**ADDENDUM NO. 3  
February 5th, 2026**

**INVITATION FOR BID (IFB)  
IFB NO. 2025-12  
RADON MITIGATION VARIOUS SITES**

This addendum to subject IFB, is a result of drawing and specification updates that occurred after the issue of the IFB dated January 12<sup>th</sup>, 2026. Additional questions are expected, but none are addressed in this addendum. The additional questions will be responded to in a follow-up addendum.

DRAWING NO.  
**A-101.1**

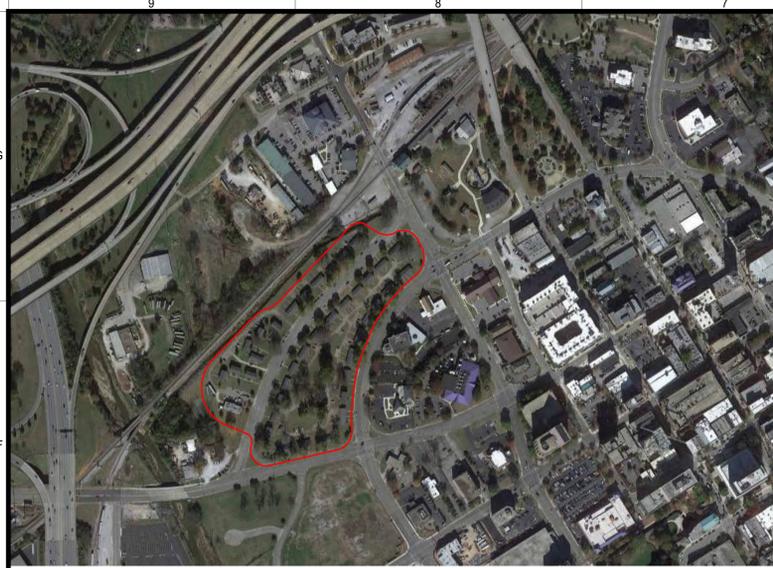
**Clarification 3.9:** *Sheet A-101.1 – Updated legend definitions. The work involves units that that tested above 4.0 pCi/L.*

DRAWING NO.  
**A-102.1**

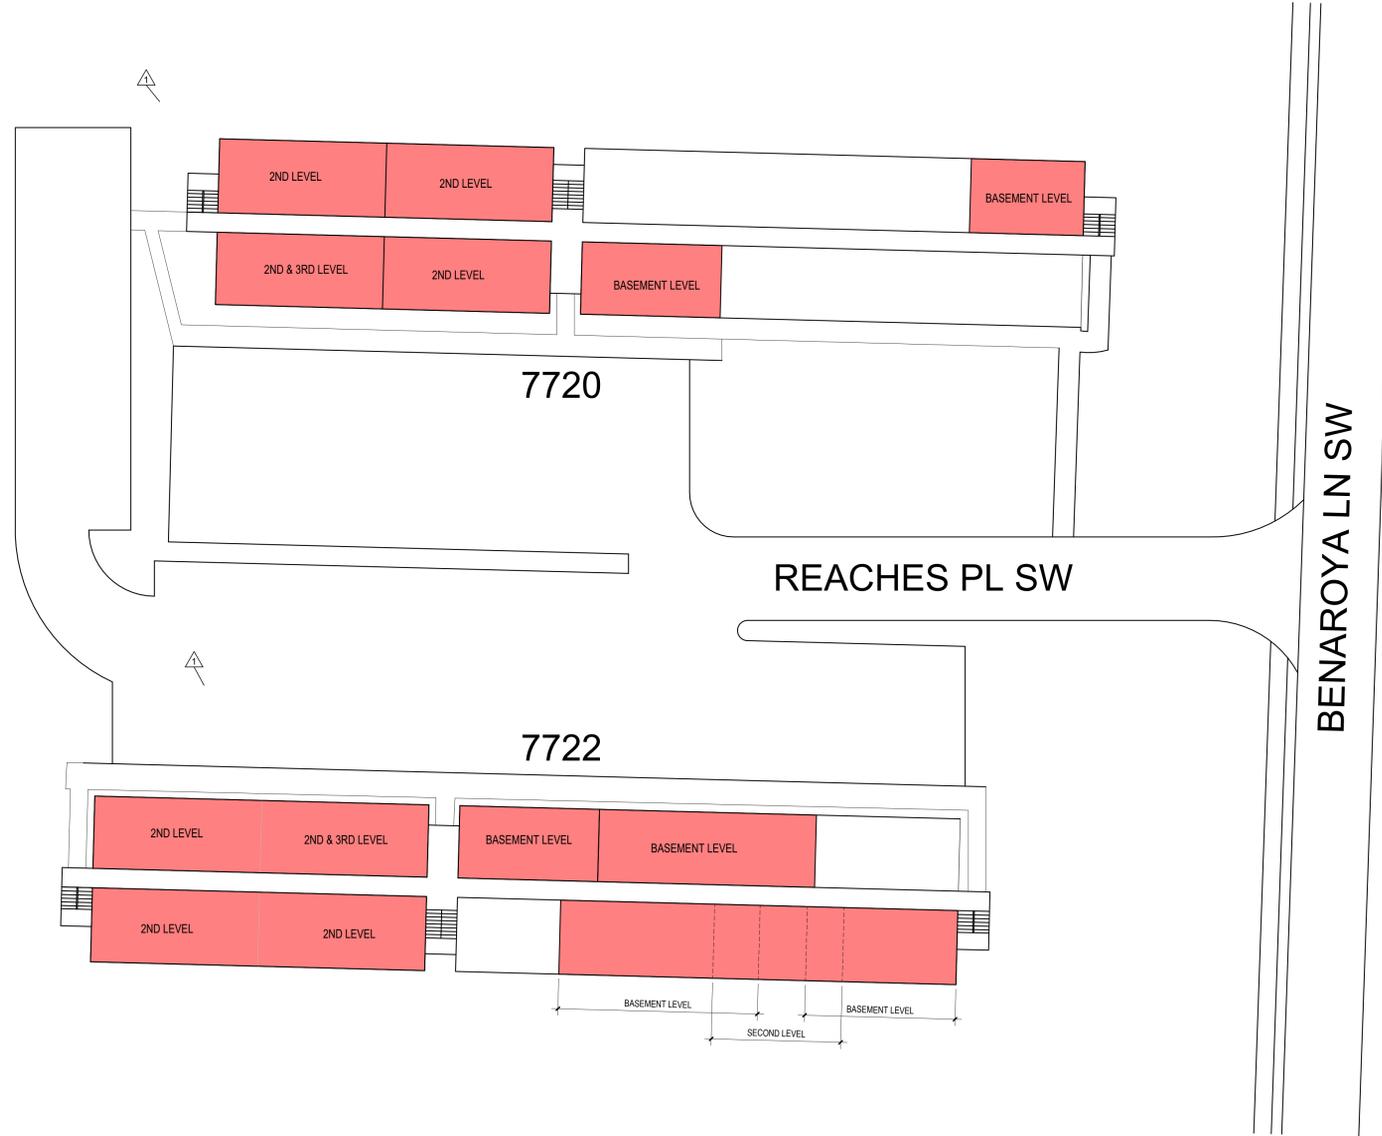
**Clarification 3.10:** *Sheet A-102.1 – Updated legend definitions. The work involves units that that tested above 4.0 pCi/L.*

DRAWING NO. **A-103.2**

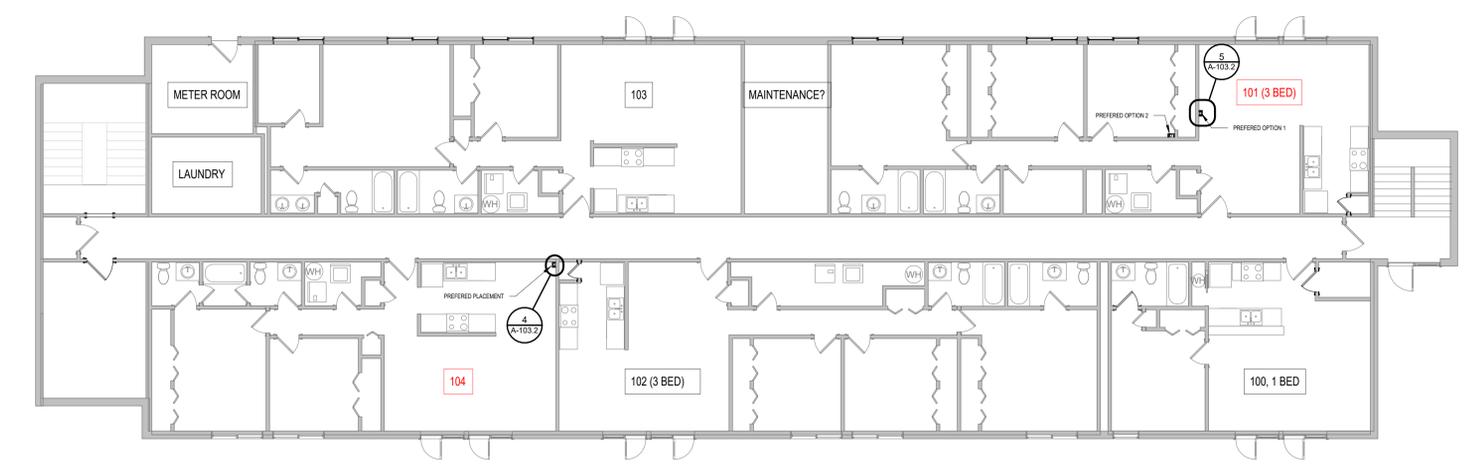
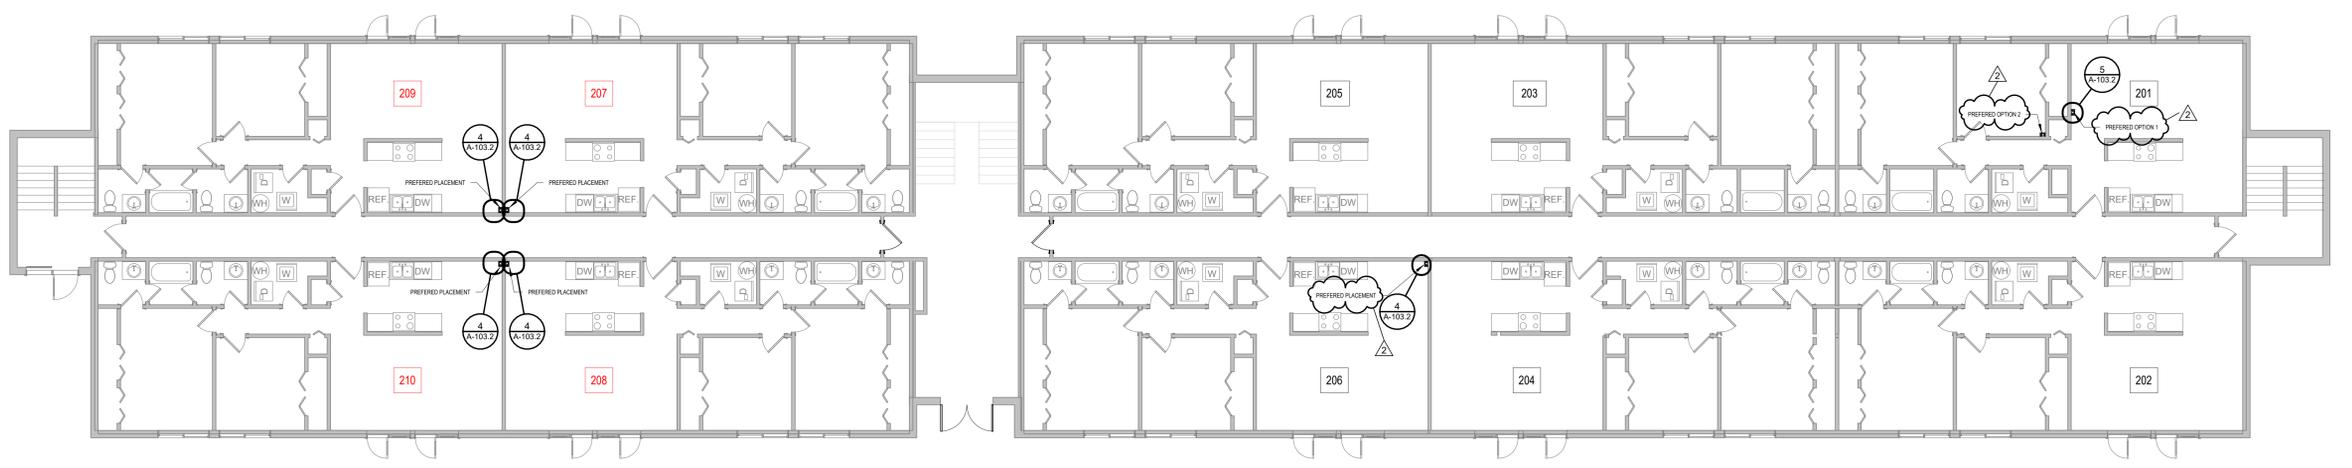
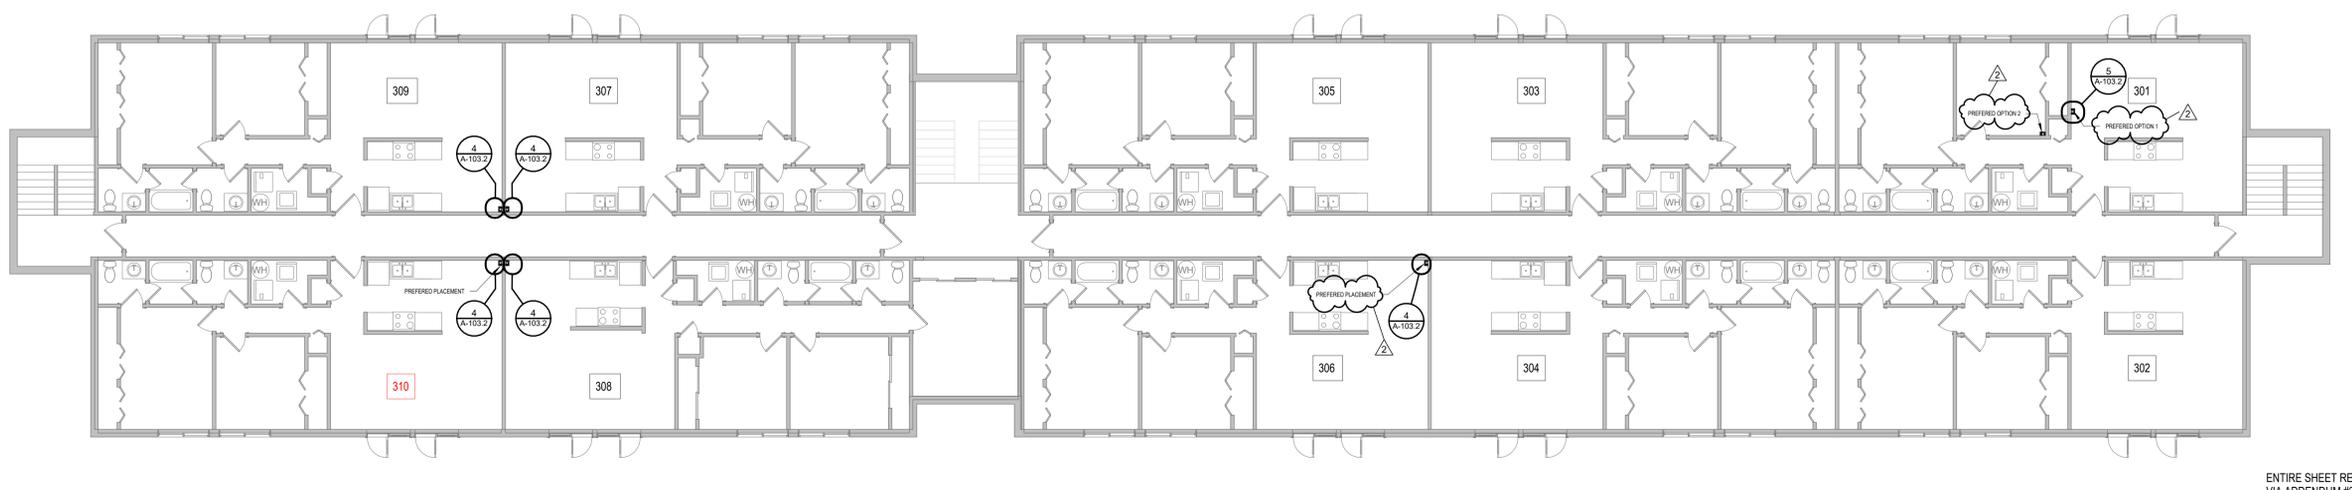
**Clarification 3.12:** *Sheet A-103.2 – Added a legend. Note: New chases may pass units that that tested below 4.0 pCi/L. Also added “preferred placement” text.*

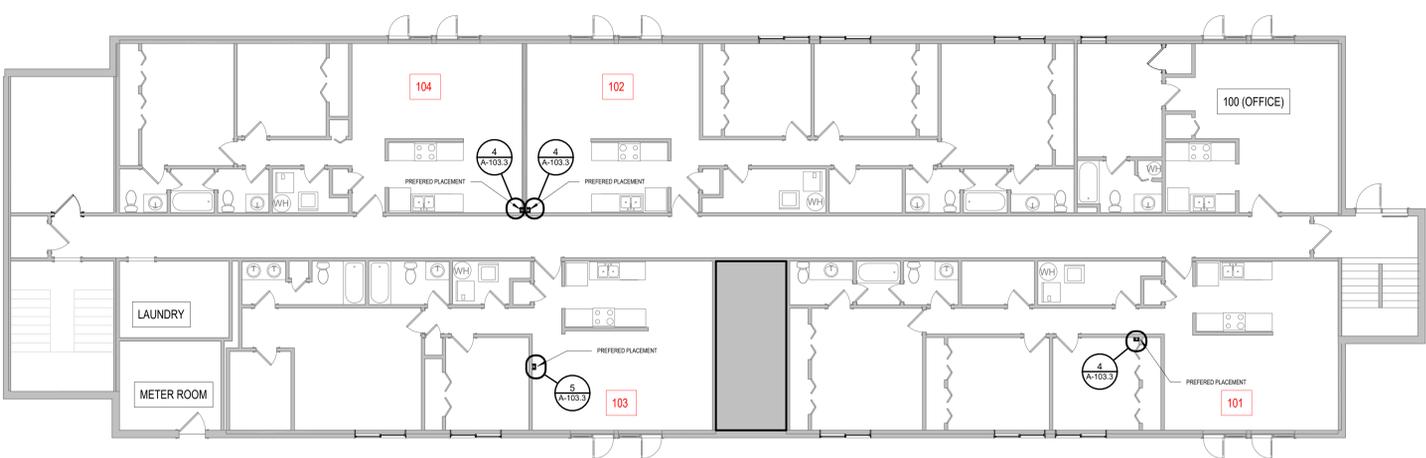
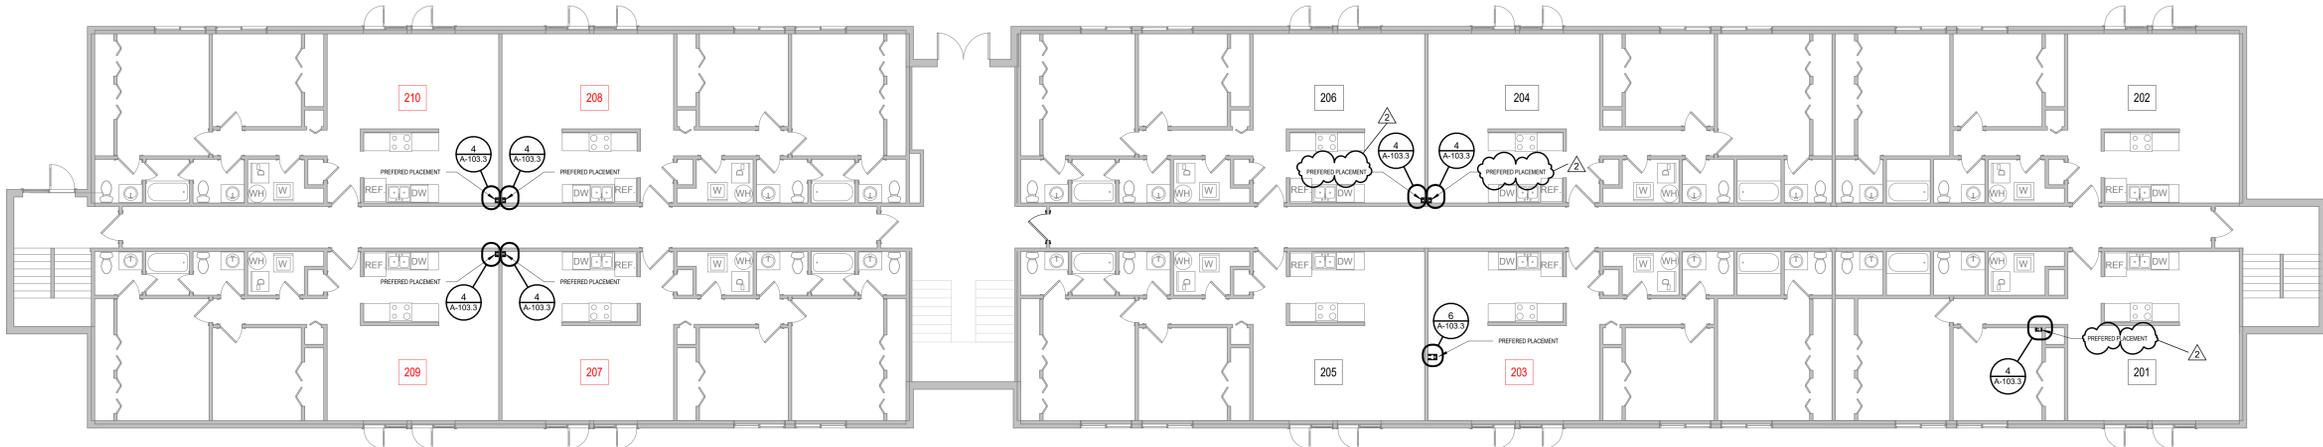
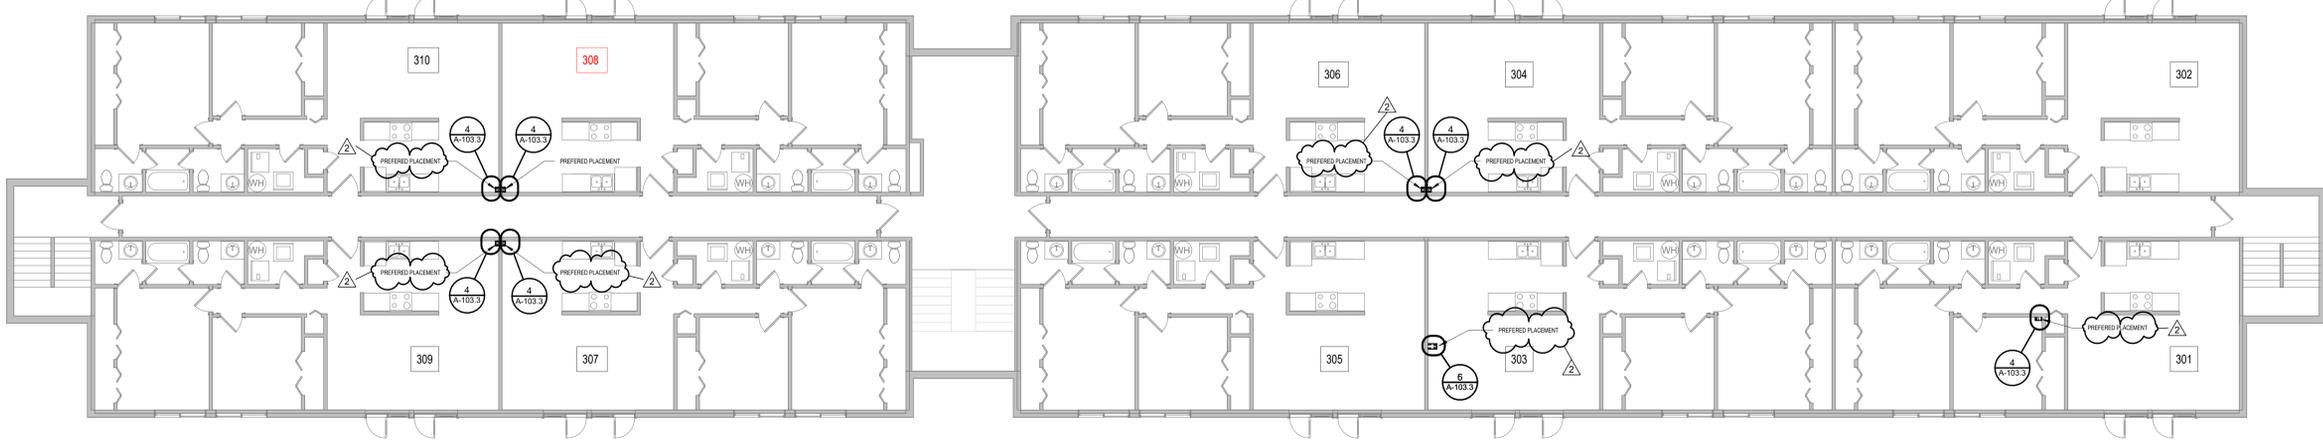
**Clarification 3.13:** *Sheet A-103.3 – Added a legend. Note: New chases may pass units that that tested below 4.0 pCi/L. Also added “preferred placement” text.*

DRAWING NO.  
**A-104.1**

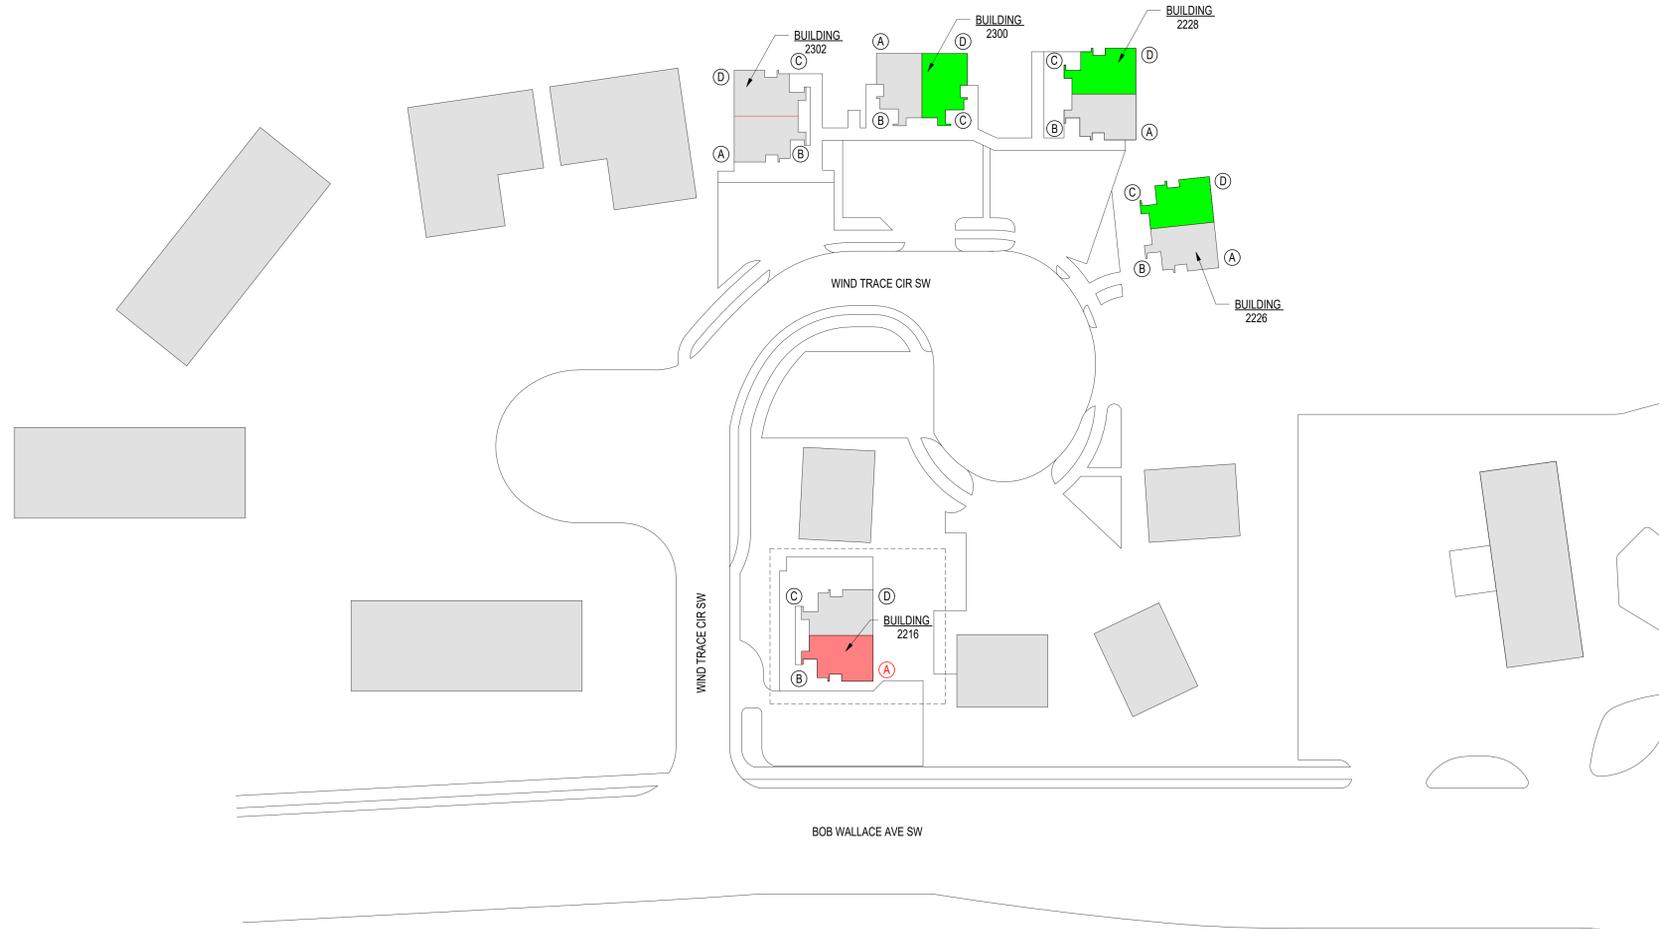
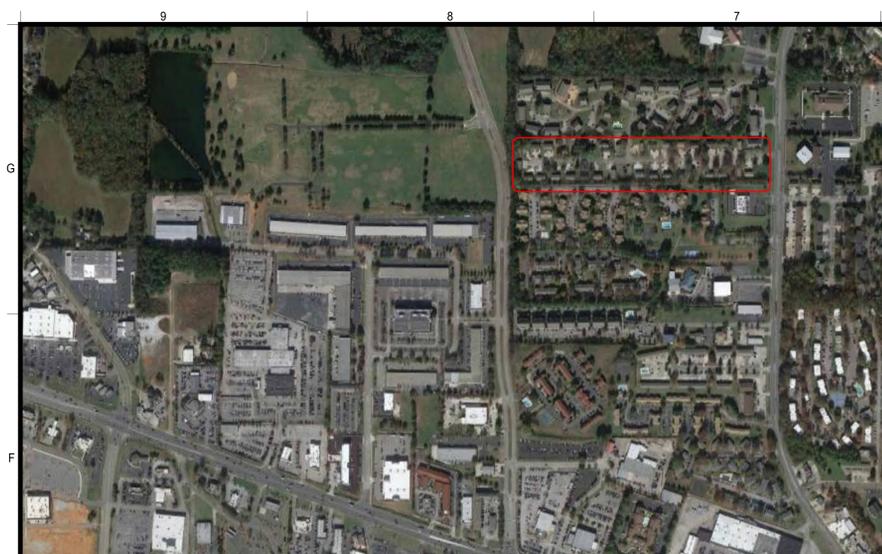
**Clarification 3.14:** *Sheet A-104.1 – Updated legend definitions. The work involves units that that tested above 4.0 pCi/L.*
